Serial ATA Technical Errata

Errata ID	01
Affected Spec Ver.	SATAii Cables and Connectors Volume 1 Rev. 1.0 (Gold)
Corrected Spec Ver.

2.3. SATA connector location on the 5.25" form factor

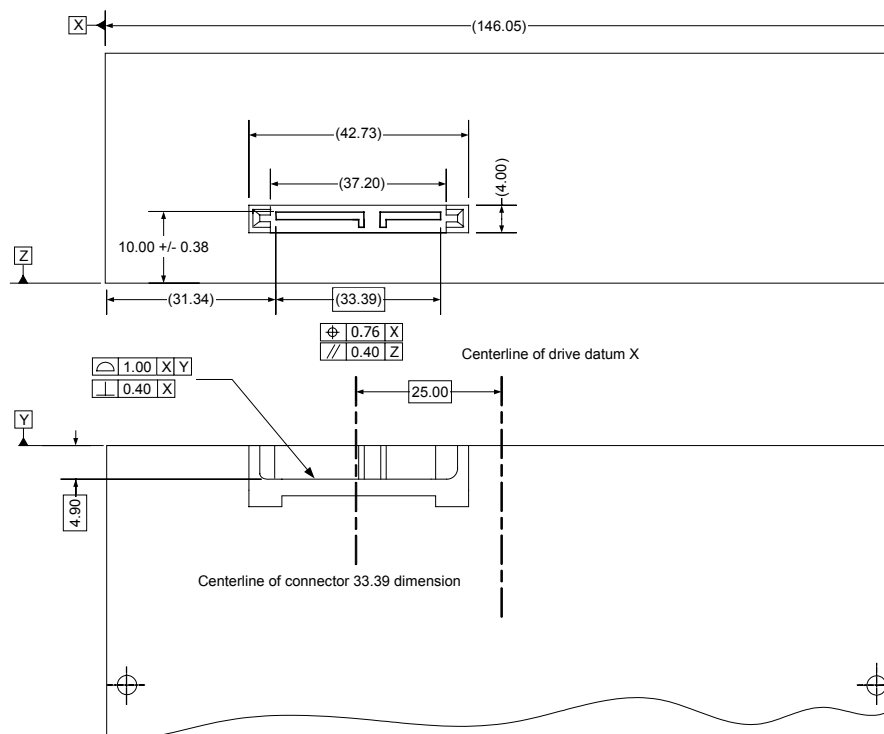
Optical 5.25" devices need the connector location to be different than the location on smaller form factors due to differences in PCB location.

Modify the text of section 2.3 and replace Figure 2.2 with the figure shown below:

Compliant 5.25. form factor Serial ATA Devices shall have connector locations ~~and keep-out areas~~ as follows. The SATA connector is nominally flush with the I/O connector end of the device form factor.
